# Safety Evaluation Report

## CESSAR-238 Nuclear Island Standard Design

Docket No. STN 50-447

Supplement No. 3

Figure 6.2-1

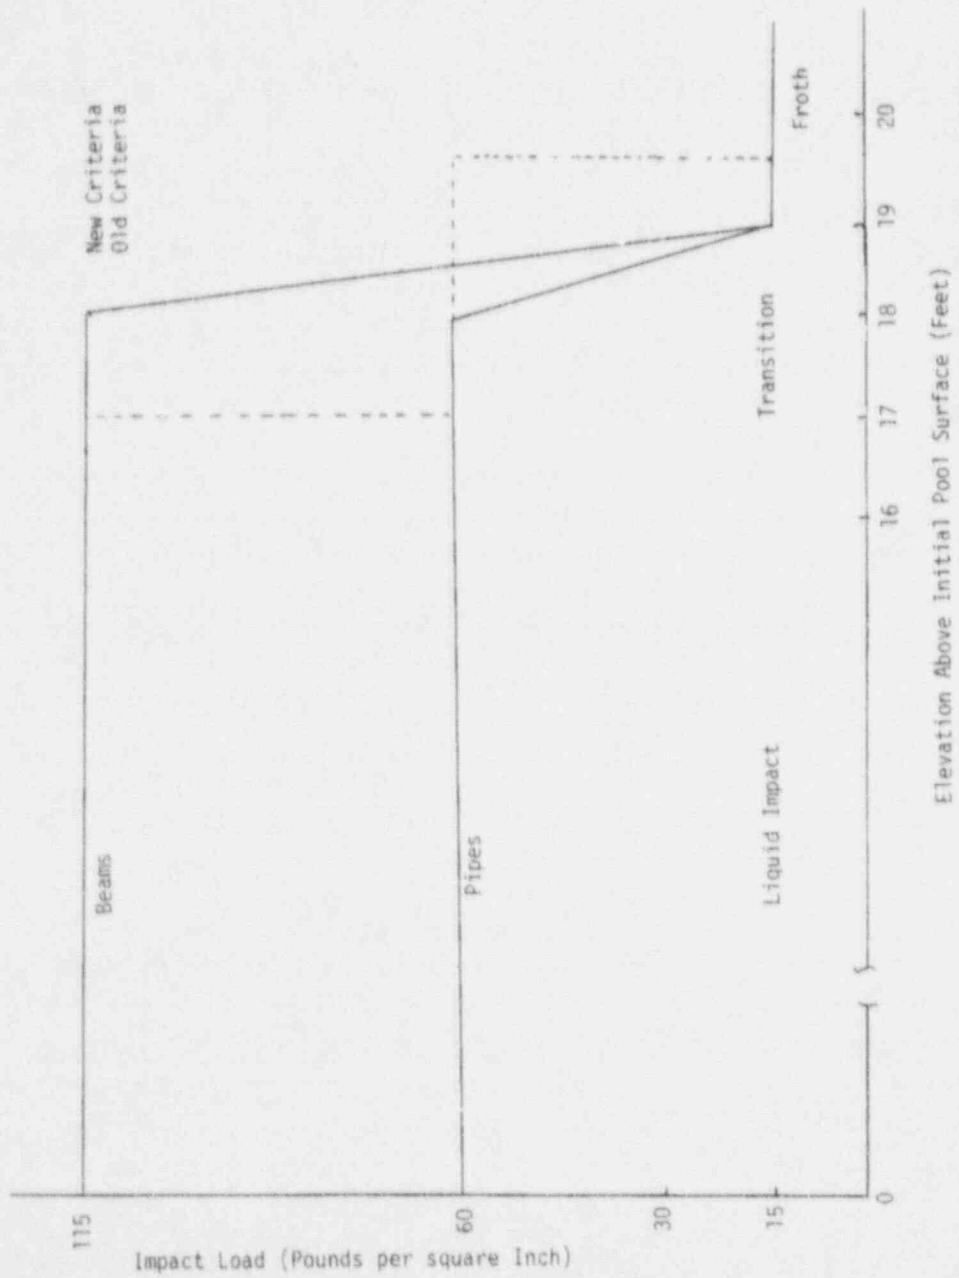
Subsequent to the issuance of PDA-1, the staff initiated a reevaluation of the suppression pool impact load criteria for beams and pipes in the transition zone (17-19.5 feet) for Mark III containments. After carefully considering the findings of our consultants and our own evaluation, we conclude that the transition impact load criteria should be modified as shown in Figure 6.2-1 of this supplement.

Figure 6.2-1 contains both the previous and revised criteria. In the revised criteria the pressure load has been increased significantly for beams in a portion of the transition region and reduced for pipes. These changes result from:

- (1) Increases in the predicted maximum pool swell velocity.
- (2) Increases in the height above the pool at which the slug thickness is one to two feet.
- (3) Our assessment of the impact characteristics of the pool slug in the one to two-foot range.

In an April 8, 1977 letter from W. Gilbert (General Electric) to S. Varga (NRC), the General Electric Company adopted these new loading criteria as one of the design bases for their GESSAR-238 Nuclear Island design. We therefore consider the pool dynamics condition on PDA-1 to be resolved.
